Subject: AP1000 COL Responses to Requests for Additional Information (TR 03)

Responses to Requests for Additional Information on Technical Report No. 03

RAI Response Number: RAI-TR03-010

Figure 3.7.1-15
Strain Dependent Properties of Rock Material

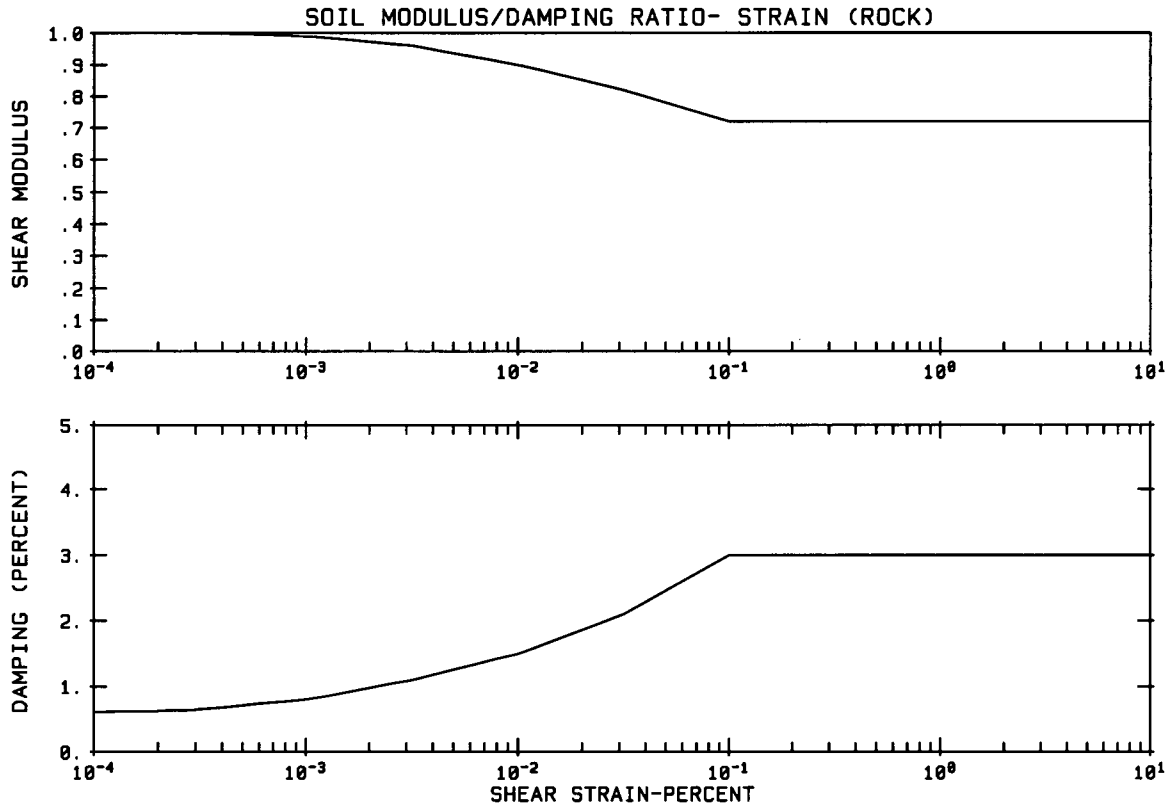
The staff's review of Tables 4.4.1-1A and 4.4.1-1B found that Westinghouse used three soil/rock degradation models in its parametric studies for selecting site conditions: Seed and Idriss 1970 soil/rock degradation curves, Idriss 1990 soil degradation curves, and EPRI 1993 soil degradation curves. For example, Westinghouse used Seed and Idriss 1970 model for two horizontal motions and EPRI 1993 soil degradation model for two rocking motions when the parametric studies were performed for the AP1000 site selection. Westinghouse is requested to provide reasons and bases for using different soil degradation models for its parametric studies.

The strain-dependent shear modulus curves for the foundation materials, together with the corresponding damping curves are taken from References 37 and 38 and are shown in Figures 3.7.1-15 and 3.7.1-16 for rock material and soil material respectively. The different curves for soil in Figure 3.7.1-16 apply to the range of depth within a soil column below grade. The strain-dependent soil material damping is limited to 15 percent of critical damping. The strain-dependent properties used in the SSI analyses for the safe shutdown earthquake are shown in Table 3.7.1-4 and Figure 3.7.1-17 for the firm rock, soft rock, upper bound soft-to-medium soil, soft-to-medium soil, and soft soil properties.

Figure RAI-TR03-15-1-Strain-iterated shear wave velocity profiles

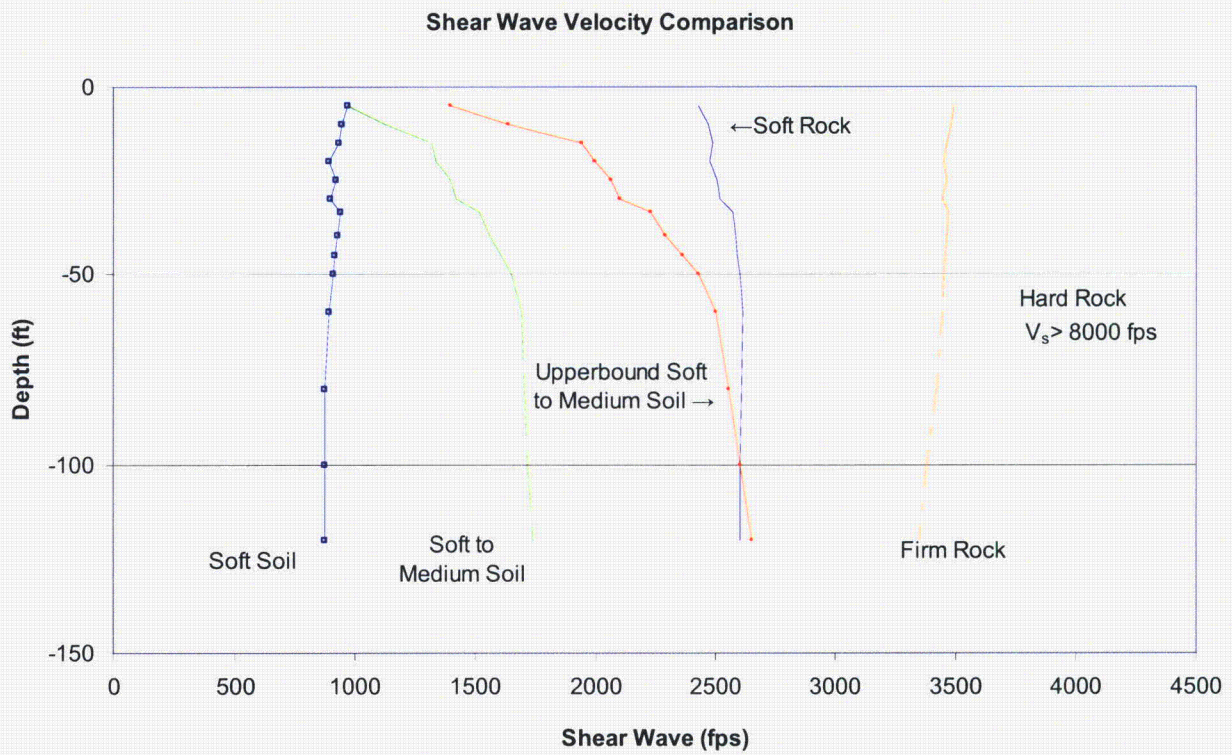
In Page 48 of 154, Westinghouse illustrated that some effects (water table, soil layering, soil degradation model, etc.) are not significant to the seismic response of the nuclear island (NI) structures. Because these results are applied for the AP1000 design, the staff requests Westinghouse provide technical basis for making these conclusions. In addition, Westinghouse needs to demonstrate the combination of these effects is also insignificant to the seismic response of the NI structures.

Westinghouse has addressed soil degradation in RAI-TR03-10. Tables of strain-iterated shear wave velocity used in the generic analyses are shown. Figure RAI-TR03-15-1 shows the bounds of these strain-iterated shear wave velocity profiles. The combination of effects of the different soil parameters is reflected in these bounds. Figure RAI-TR03-15-2 shows how a COL applicant could demonstrate that the site is enveloped by generic seismic design basis. The applicant would define its site geotechnical parameters as defined in DCD Section 2.5 and would justify why the site is within the bounds of the AP1000 generic analyses that have been considered in this technical report. These parameters would include the soil profiles used in the PSHA (probabilistic seismic hazard analysis) analyses, which could then be compared to Figure

Figure RAI-TR03-020-1 - Rev 4 SCV

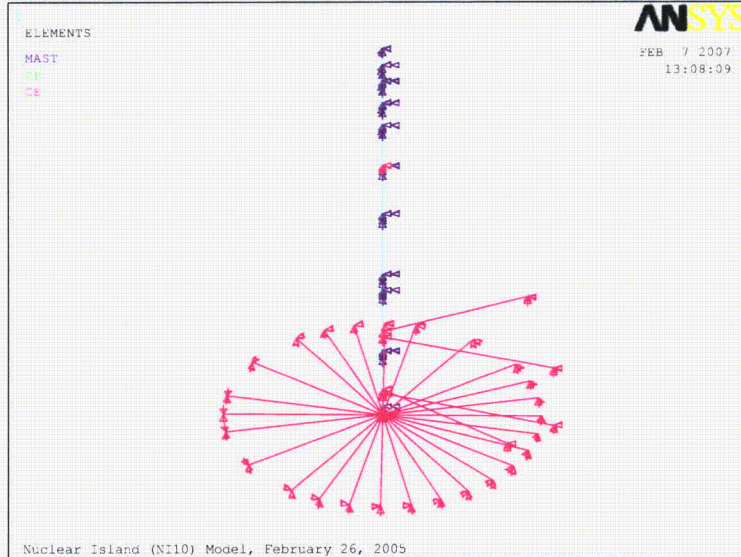
- a. Comparison of Figure 6.1-4 to Figure 6.1-6, and comparison of the stick model results to the FE model results at the top of the SCV in Figure 6.1-6, raises a question about the connectivity of the bottom of the SCV stick to the CIS FE model, at node 130401. The staff requests Westinghouse to provide a detailed technical explanation for the following:
 - a. Why is the x-direction spectral peak at node 130412 reduced by 1/3 (approx. 4.2 vs. 6.3), while the y-direction spectral peak at node 130412 is only reduced by 1/11 (approx. 6.6 vs. 7.2)? What mechanism has caused the ratio of y to x to change from 1.09 for the stick model to 1.57 for the FE model?
 - b. Why does the vertical spectrum comparison in Figure 6.1-6 show (1) an increase in spectral peak for the FE model, compared to the stick model, and (2) a significant shift in the frequency of the peak?

The connection of the bottom of the SCV stick to the CIS finite element model at node 130401 was reviewed. The connectivity, via constraint equations, is shown in Figure RAI-TR03-020-1. As seen the connectivity (identified as "Rev 4 model") is not symmetric around the SCV model. This connectivity was changed by adding six more connections so that it is symmetric. It is identified as "All Nodes" and is shown in Figure RAI-TR03-020-2. The vertical motion for the CIS interface nodes is tied rigidly to the vertical motion and rotation about the x-axis and y-axis of Node 130401 at the base of the SCV stick model. The tangential motion is tied rigidly to the horizontal motion and rotation about the z-axis of the same node. No constraints were placed for the radial direction of the CIS.

Figure RAI-TR03-022-1-Relative Displacement of Node 3360, top of Shield Building

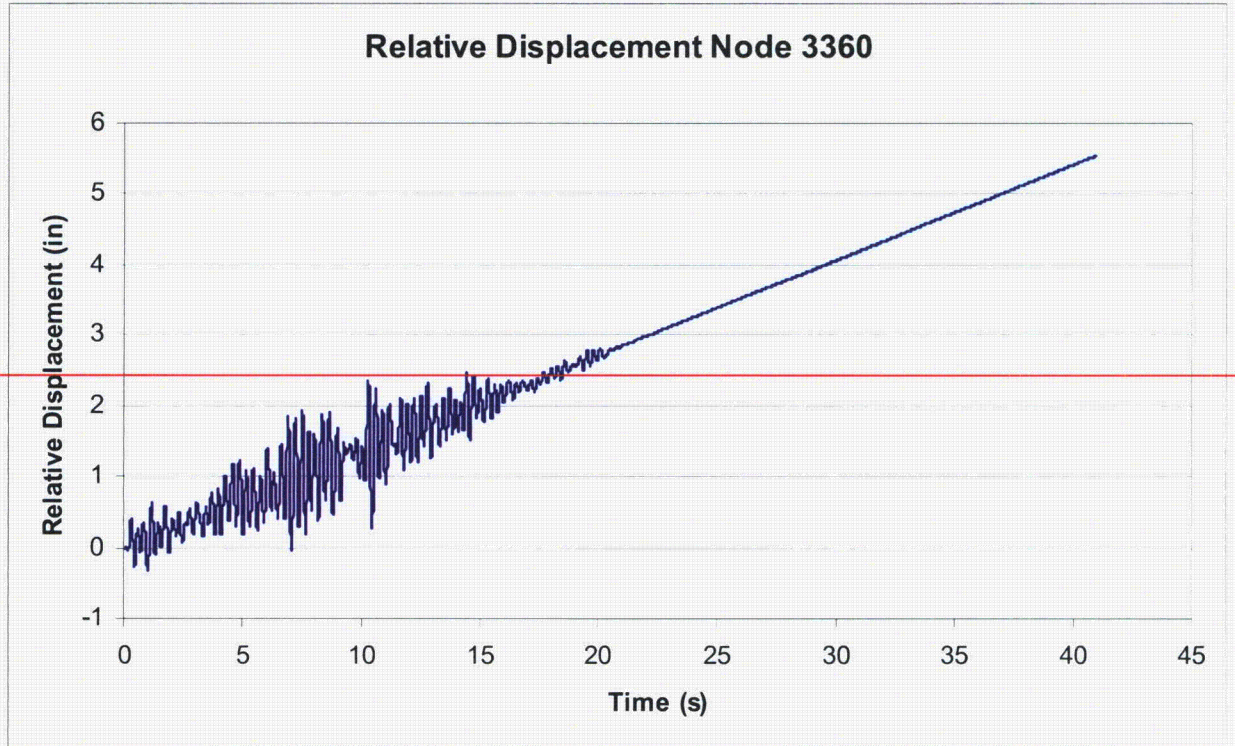
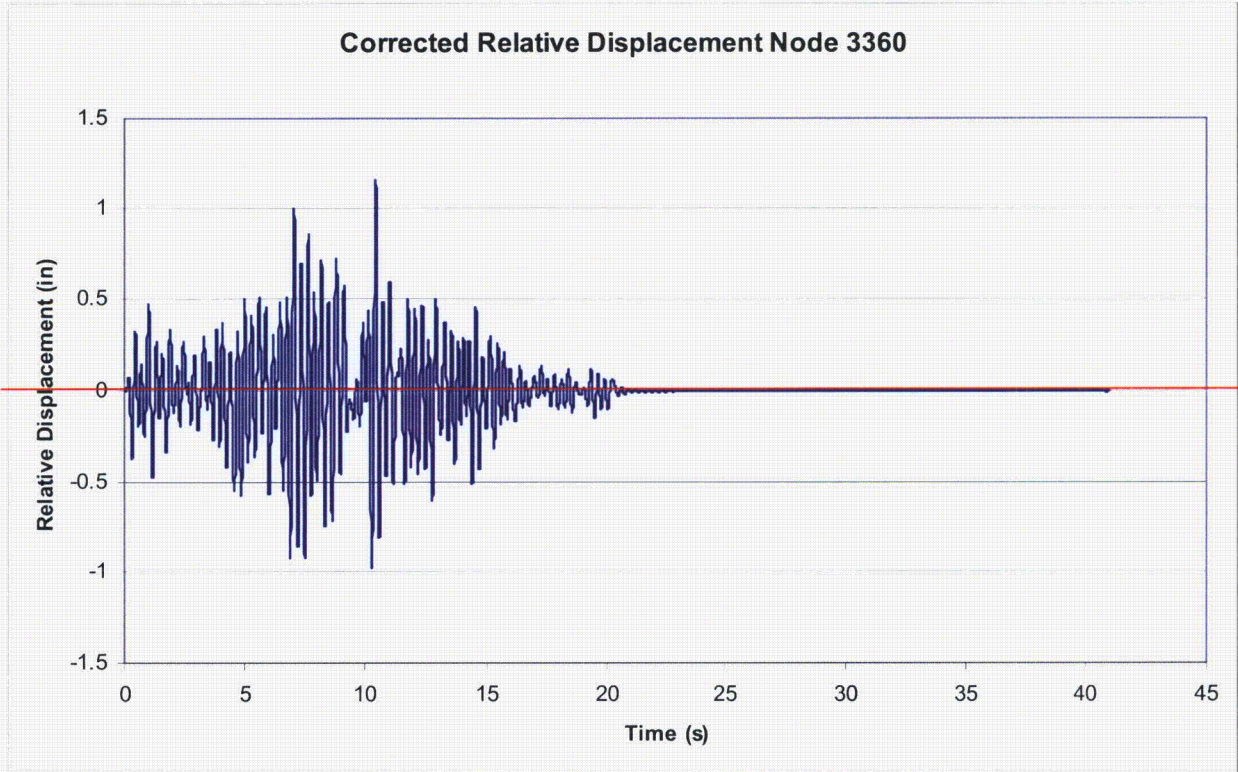
- a. Are the deflections in the tables a consistent set, based on the worst-case time history result, or are they an envelope of maximum deflections from all the time history results?
- b. How do these tabulated deflections compare to the corresponding deflections obtained from the equivalent static acceleration analyses? Please provide a tabulated comparison, and an explanation of any significant differences.

~~Deflections have been developed using the model with the robust shield building design. These displacements for the soil and hard rock cases have been obtained relative to the translation of a reference node at the bottom of the foundation and near the center of the basemat. Coordinates of this reference node are x= 993.00 ft, y= 986.00 ft and z= 60.50 ft. The deflections have been revised to remove drift. The absolute displacement time histories are calculated from the nodal time histories accelerations. When the relative displacements are plotted there is a constant slope as shown in Figure RAI-TR03-022-1. To correct this drift, the slope of the relative displacement multiplied by the time is subtracted from the relative displacement at each time step. Presented in Figure RAI-TR03-022-2 is the drift corrected relative displacement.~~
